Spokane Design Review Board

Wednesday, May 26, 2021

5:40 – 7:15	5) Avista Metro Substation – Recommendation Meeting	Taylor Berberich
	• Staff Report.....	15-20 m
	• Applicant Presentation.....	25 m
	• Public Comments and Board Q & A	25 m
	• Board Discussion and Motion(s).....	45 m

DESIGN REVIEW RESPONSE | MAY 2021

SOUTH ELEVATION @ 3RD AVENUE

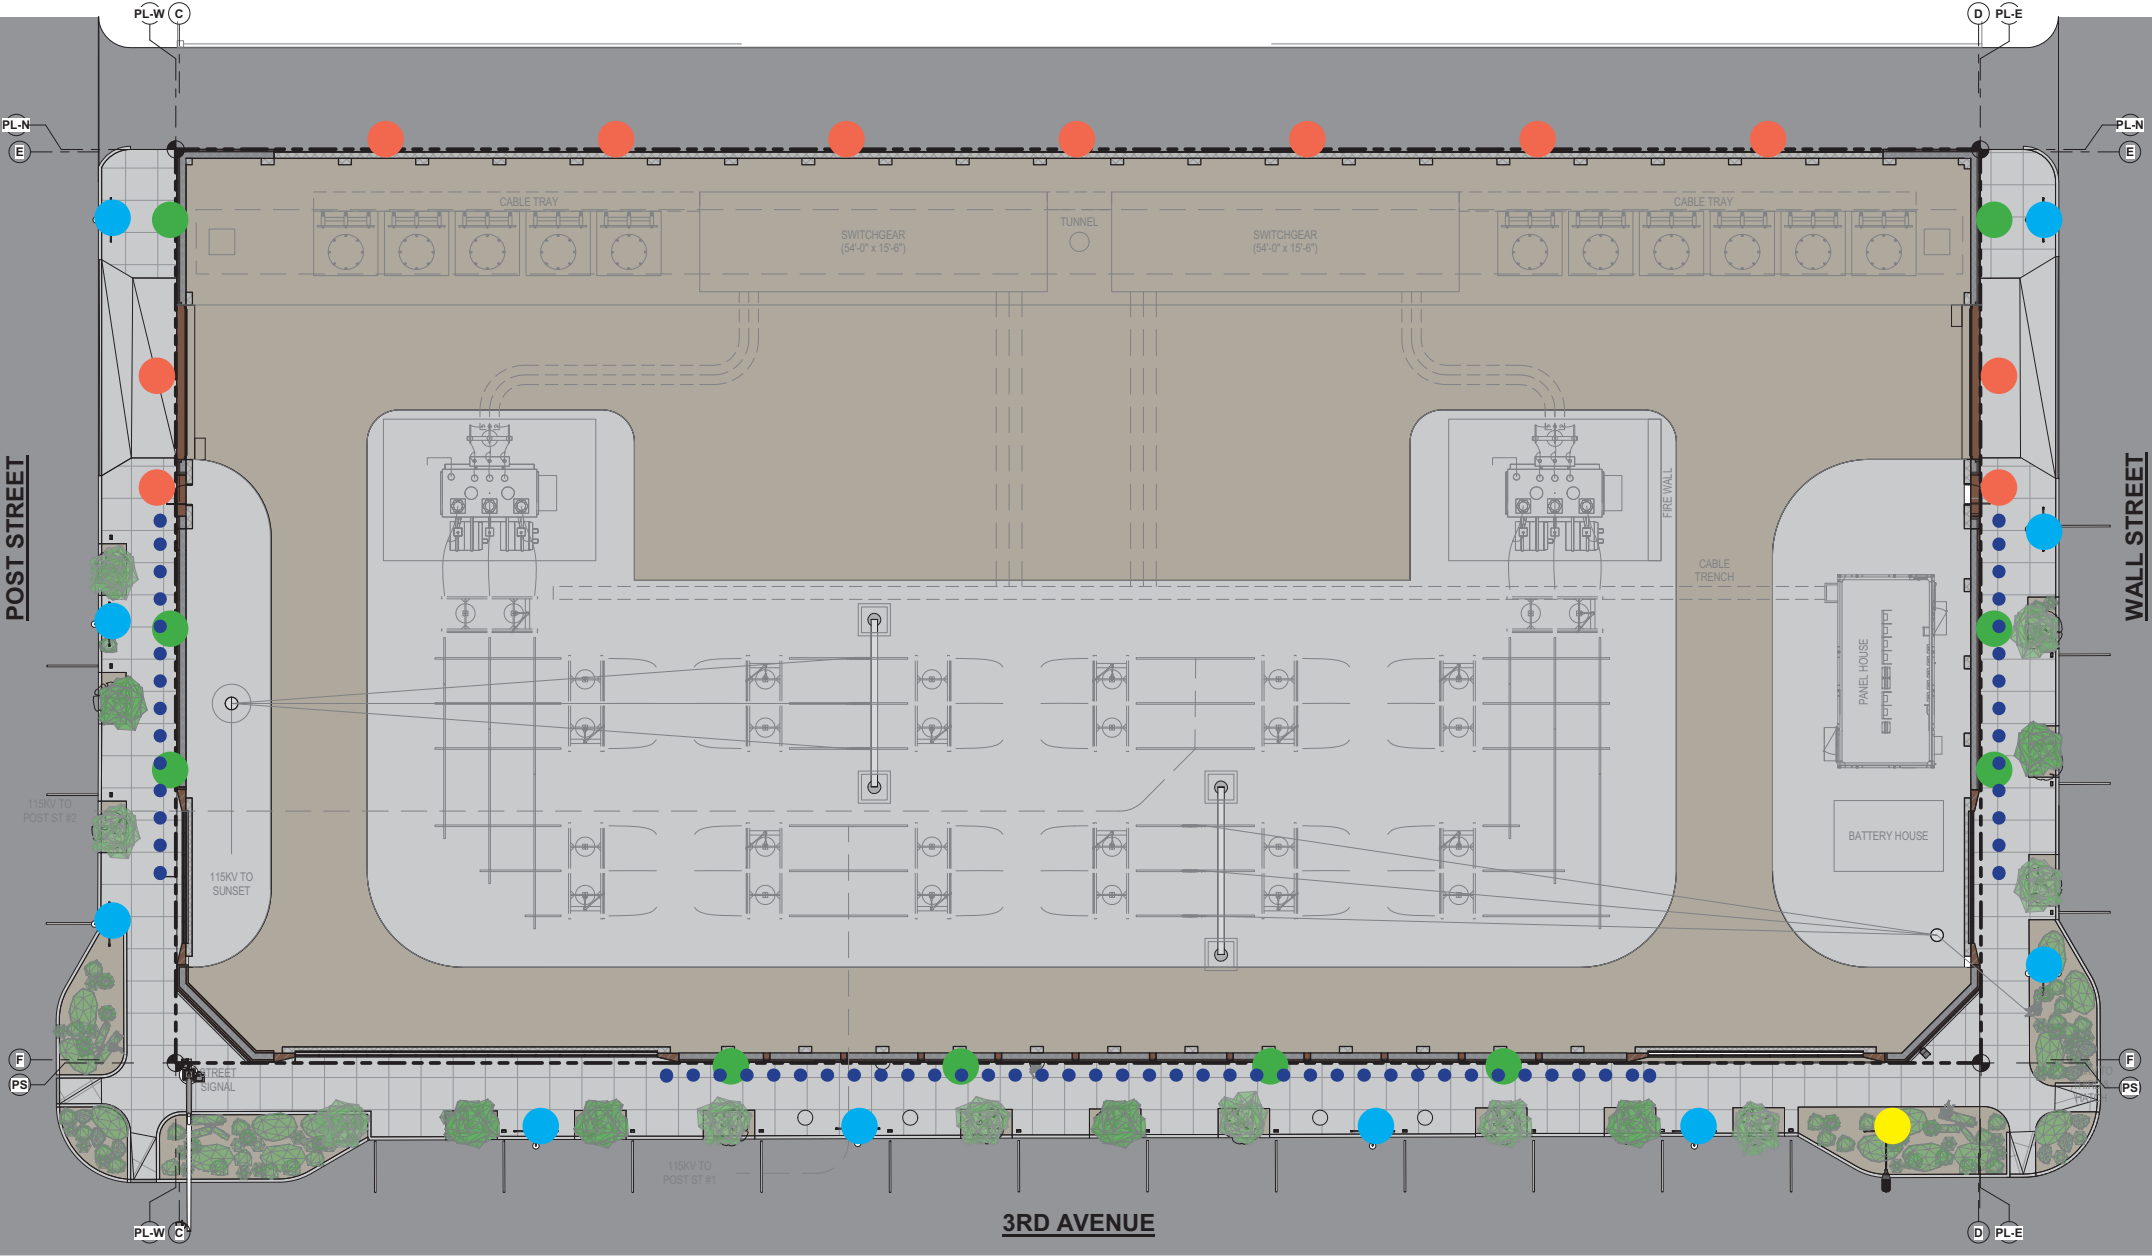
3. The slit windows are composed in a regular pattern along the 3rd Avenue frontage, this does not seem to coordinate with the proposed locations of seating (which does provide some mid-block level of activity). Is there an opportunity to provide a connection between these two design elements?

4. The applicant has indicated the only lighting inside the enclosure would be motion activated task lighting. Is there an opportunity to use glass treatments at the slit windows to provide a more engaging viewing experience that may allude to the shifting RGB displays in the proposed light boxes?

CONCEPT LIGHTING PLAN

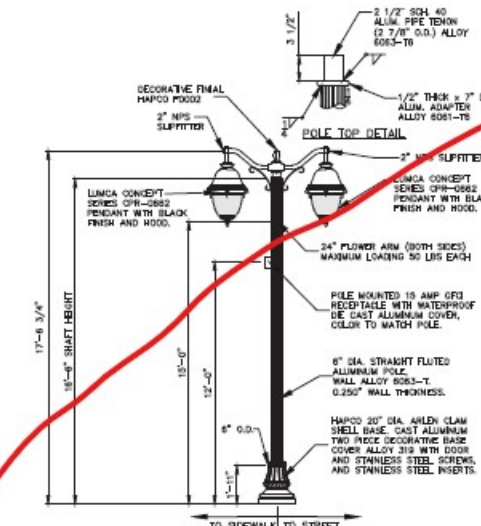
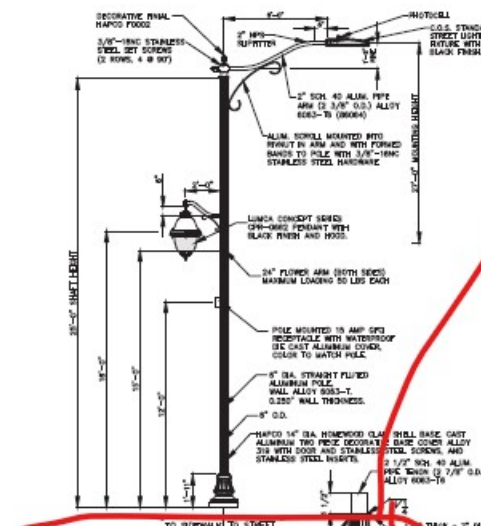
Should be S2B, Standard Plan J-206
